NOTICE OF PROPOSED DEVELOPMENT

**PROPOSED DEVELOPMENT:
ADDITIONS TO DWELLING**

APPLICATION NO: DA 2025 /47 1

FURTHER INFORMATION REQUEST

SITE PLAN

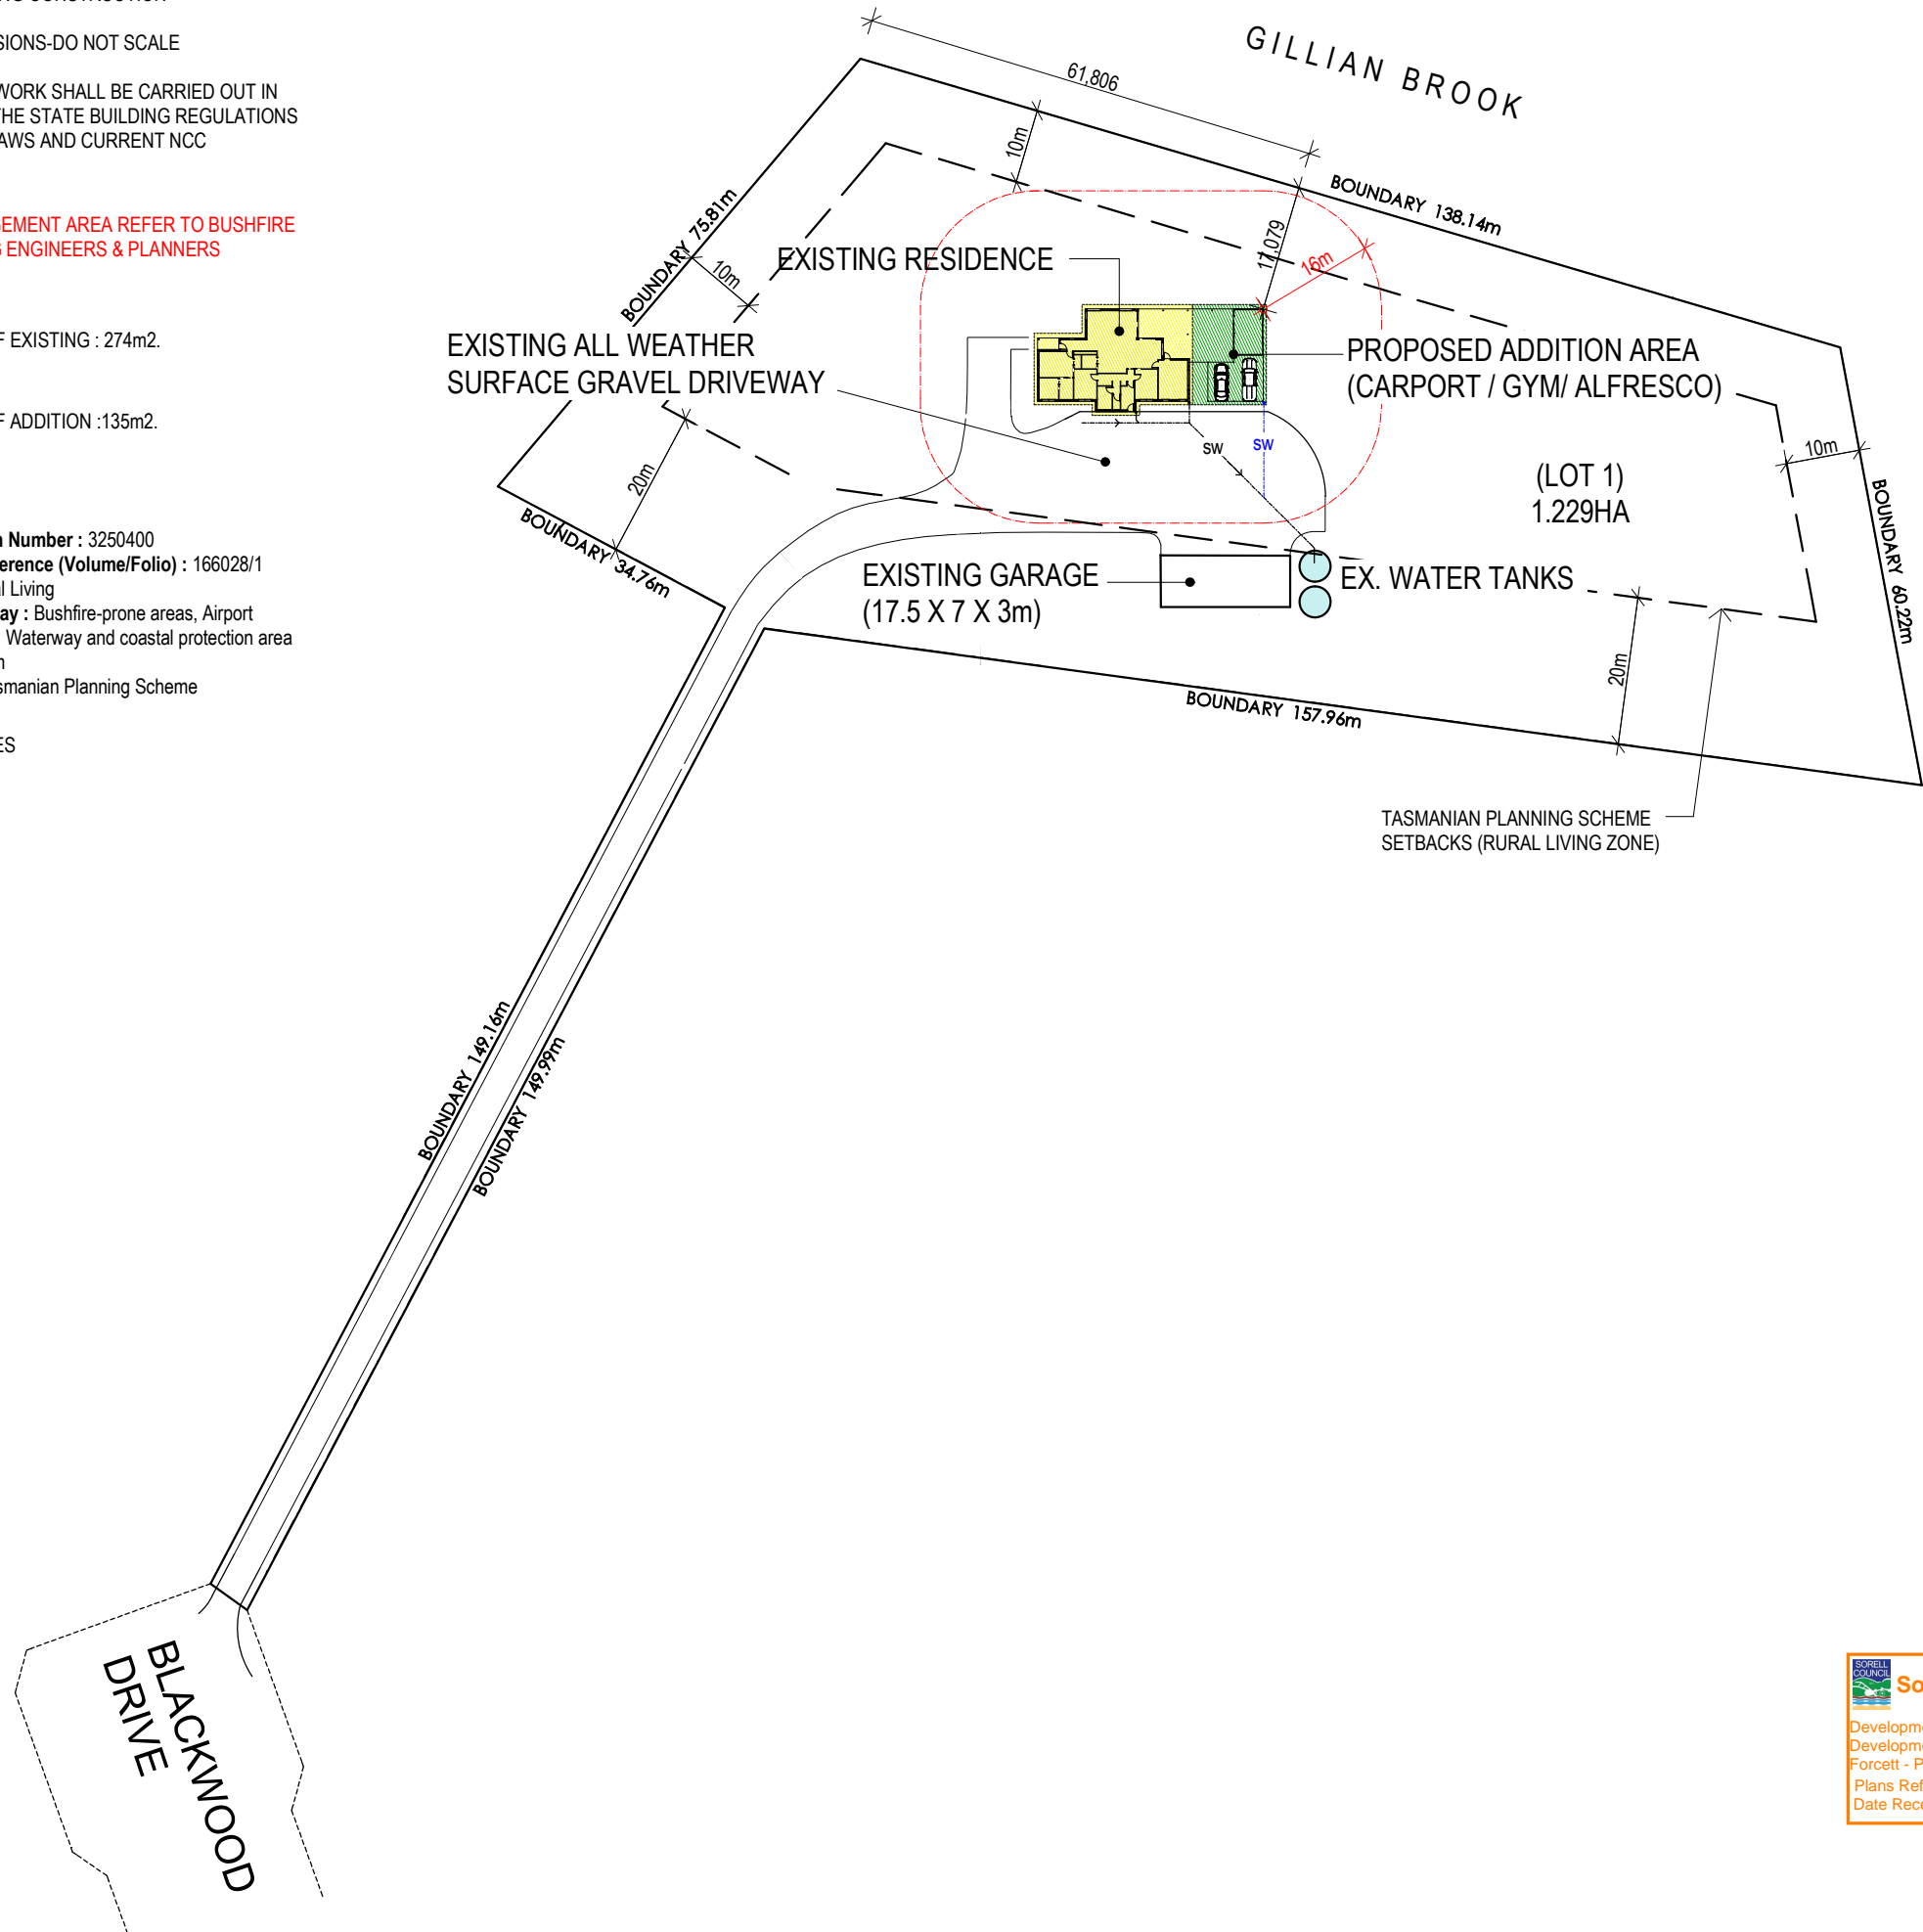
2. A written statement and associated amended plans that address and respond to the 'Performance Criteria' of the Rural Living Zone – 11.4.1 P1 Site Coverage, Development Standards for Building and Works of the Scheme.

THE PROPOSAL IS CONSISTANT WITH OTHER DWELLINGS IN THE SUUROUNDING AREA. TOTAL PROPOSED SITE COVERAGE IS 531.50m².

THE PROPOSAL SITE IS 1.229HA IN AREA WITH LARGE OPEN AREAS AWAY FROM AND DOWNSLOPE FROM THE PROPOSAL. STORMWATER FROM THE PROPOSAL IS TO BE COLLECTED, STORED AND RE-USED ON SITE AND OVERFLOW MEASURES TO BE DETERMINED BY SUITABLY QUALIFIED PERSONS.
i.e. GEO TECHNICAL

THE PROPOSAL IS AN ADDITION TO THE EXISTING BUILDING WITH EXTENTION OF THE ROOFLINE. THE TOTAL DWELLING COVERAGE OF 409m2 IN KEEPING WITH THE SCALE AND DESIGN OF NEIGHBOURING PROERTIES IN THE SUBDIVISION.
